No. 1425

BROWNING MACHINE GUN, CALIBER .30 M1919A4
MODIFIED WITH BIPOD AND SHOULDER REST.

SUBJECT: Browning Machine Gun, Caliber .30, M1919A4, Modified with Bipod and Shoulder Rest.

TEST OF BROWNING MACHINE GUN, CALIBER .30, M1919A4, MODIFIED WITH BIPOD AND SHOULDER REST

PROPOSED RE-DESIGN OF FRONT BEARING AND BARREL BEARING SLEEVE

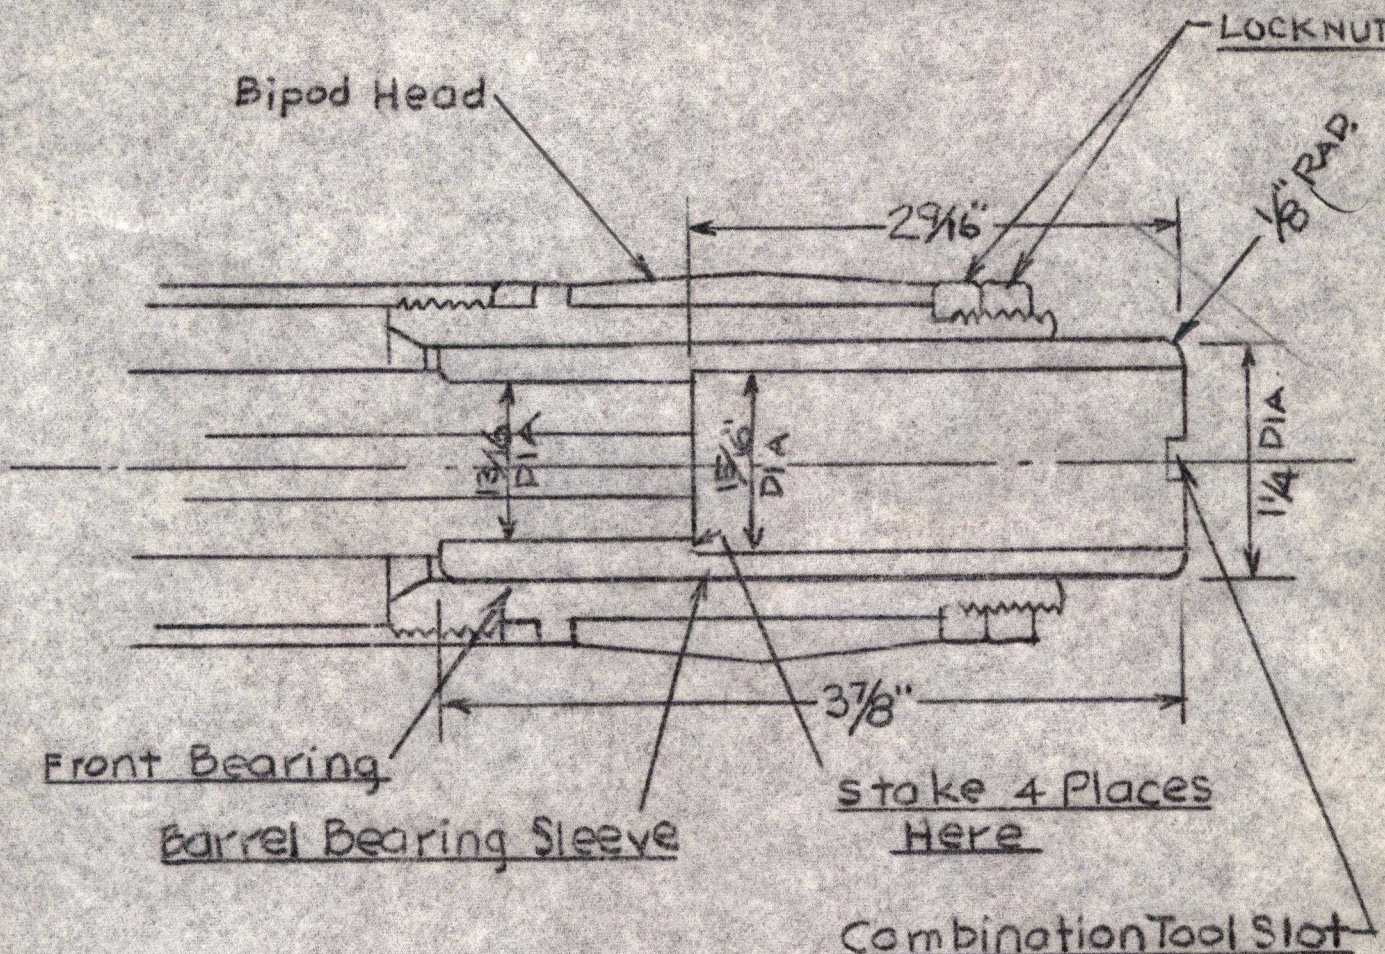
(1) The bearing sleeve on the barrel was replaced by one which projected through the front bearing 1/2 inch and which was slotted to receive the combination tool. The ends of this sleeve were rounded with a 3/16" radius to eliminate the sleeve catching in the bearing. The slots were provided so the barrel could be removed without "stripping" the gun. (See Appendix "C".)

(1) A redesign of the barrel sleeve to permit

(a) Withdrawal of the barrel without the sleeve catching on the receiver when stripping the gun,

(b) Insertion of the barrel without the sleeve catching on the front bearing when assembling,

(c) To permit withdrawal and insertion of the barrel from the front without stripping, and

(d) Adjustment of headspace from the front and elimination of marring the barrel locking spring notches.

e. The snap-ring for securing the front bearing is inefficient. It comes off too easily and one was lost during the tests. It should be replaced by lock nuts as shown in Appendix "C".

(1) Redesign of barrel sleeve in accordance with Inclosure No. 1. This permits removal of the barrel from the front end and eliminates carbon deposit in bearing. The barrel front bearing on the gun submitted for test is unsatisfactory due to the fact that it interferes with the rapid removal and replacement of the barrel (via back end) by catching on various projections.

(2) Eliminate snap ring and snap ring groove from barrel front bearing and replace with lock nut ur nuts, locking against shoulder of bearing. Present snap ring was pulled off several times during tests. One was lost.

RE-DESIGNED HEAD OF BIPOD LEG

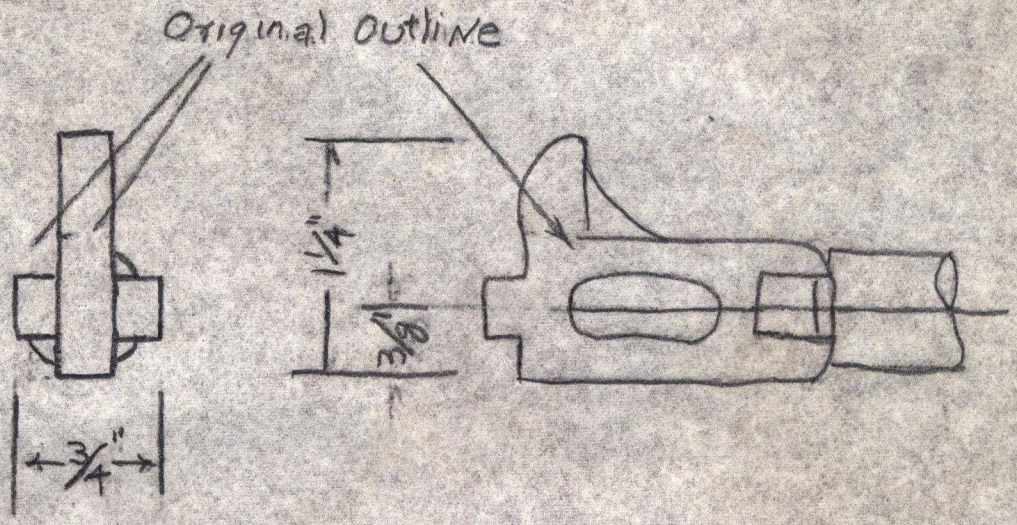
(2) The heads of the bipod legs were changed to give a positive lock when folded back for carrying. (See Appendix "D").

(2) Redesign of the heads of the bipod legs to prevent their dropping from the "folded back" position in carrying.

b. Bipod Legs (Essential). Redesign heads of bipod legs as shown in Inclosure No. 2. Present bipod legs, when in the "folded back" position, jar loose and fall loosely into firing position.

Gun as received.

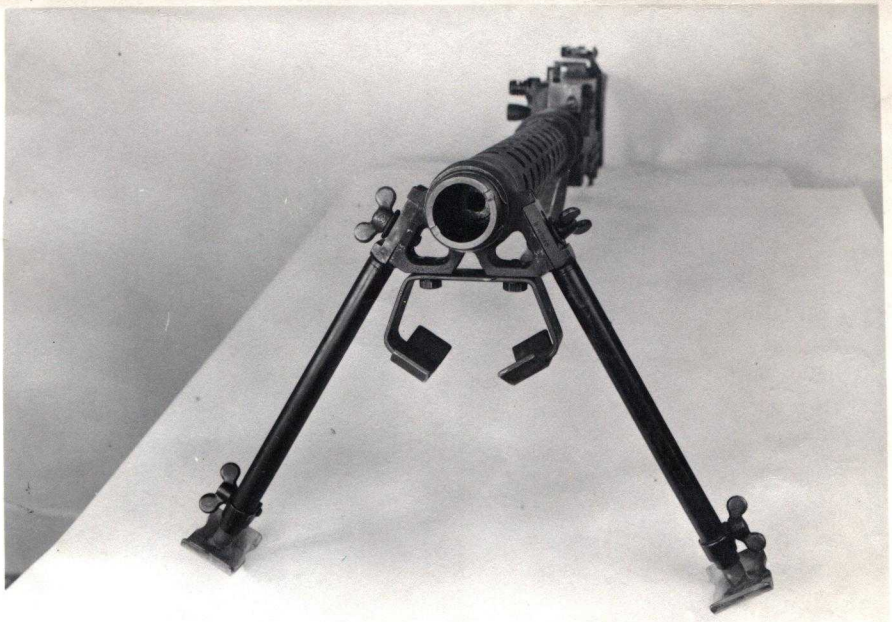
Note location of muzzle of barrel in front bearing.

Bipod Legs.

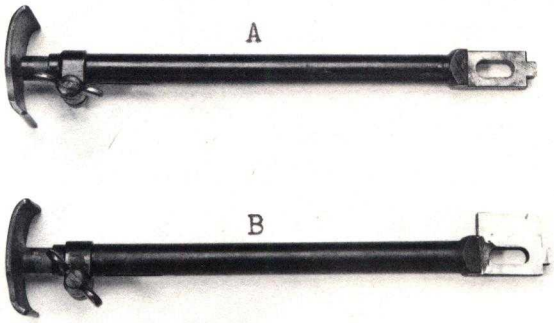
A - As received.
B - As altered.

Note difference in heads.

Gun as altered.

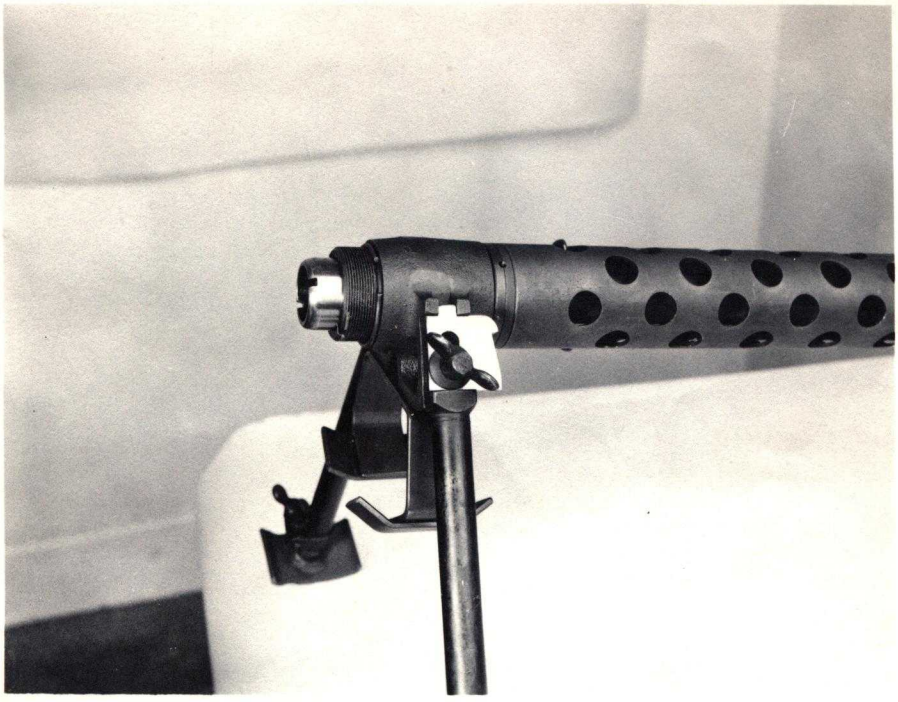
Note projecting barrel sleeve from front bearing, slots in barrel sleeve and bipod leg heads.
